August 26, 2014

Daniel Petrik  
MRCCA Rulemaking Project  
Minnesota DNR, Ecological and Water Resources Division  
500 Lafayette Road, Box 25  
St. Paul, MN 55155-4025

Our comments are organized into parts and subparts that follow the same order as the rules, with a section on the district maps and Table 1 at the end of the document. A brief overview summarizing our key issues is provided at the beginning of this document, followed by our detailed comments.

**Figure 5. Inver Grove Heights District Map**

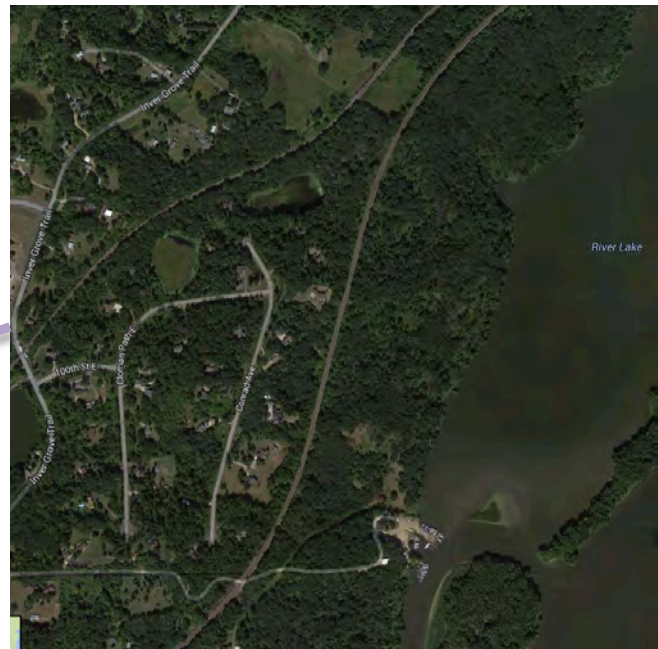
The CA-SR boundary in the vicinity of Pine Bend Bluffs and River Lake appears to be in the wrong place. The line appears to follow the area bike trail that cuts across the bluff face. The portion of land that feels truly separated from river follows the road in that location. The road is behind the blufftop and slightly lower in elevation. We would like to see the CA-SR boundary follow the road in this location or insert the CA-RN district in-between the trail and the road as the area is very residential, has unique scenic topography and high ecological value. These resources could be diminished in the future if governed by underlying zoning (see Figures 5 & 6).
